DART AEROSPACE LTD		Work Order: 53257
Description: Crosstube Assembly (205/212/412 High Fwd)		Part Number: D212-664-141
Inspection Dwg: D212-664-141 Rev: C		Page 1 of 1

DESIGN PH	DRAWN BY PH	DART AEROSPACE LTD HAWKESBURY, ONTARIO, CANADA	
CHECKED GP	APPROVED PH	DRAWING NO. D212-664-141	REV. C SHEET 1 OF 3
DATE 07.03.08		TITLE XTUBE ASS'Y (205/212/412 HI FWD) NTS	
A	00.12.12	NEW ISSUE	
B	05.02.04	ADD HOLES FOR COMPATABILITY WITH BHT/AA SKIDTUBES	
C	07.03.08	REMOVE -851 ABRASION STRIP; ADD MAGNOBOND 6398, CUSHION, REVERSE CLAMPS

DRAWING NO. D212-664-141	TITLE CROSSTUBE	REV. C	DART AEROSPACE LTD ENGINEERING ORDER		D.E.O. NO. D212-664-141-C-1	SHEET NO. SHEET 1 OF 1	SCALE NTS
DRAWN <i>AD</i>	CHECKED <i>RS</i>	MFG. APPR. <i>LR</i>	APPROVED <i>MD</i>		DE APPR. <i>TH</i>		
DATE 09.05.01	DATE 09.06.15	DATE 09.06.15	DATE 09/06/16		DATE 09/06/16

ADD THE FOLLOWING CROSSTUBE ASSEMBLY:

FIGURE 1 - SUPPORT INSTALLATION

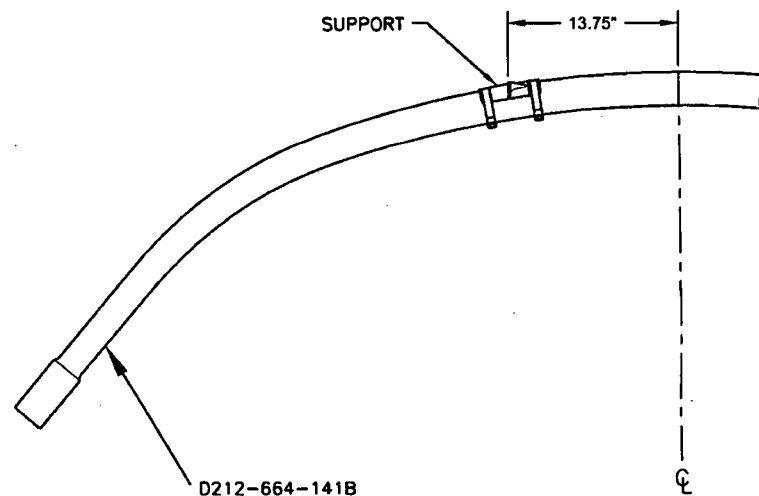
Part Number	Description
D212-664-141B	CROSSTUBE ASSEMBLY (214 HIGH FWD)

THE D212-664-141B CROSSTUBE HAS THE SAME PARTS LIST AS THE D212-664-141 CROSSTUBE. HOWEVER, INSTALL THE SUPPORTS AS SHOWN IN FIGURE 1 OF THIS ENGINEERING ORDER. THE NEW KIT IS OTHERWISE ASSEMBLED PER THE D212-664-141 CROSSTUBE.
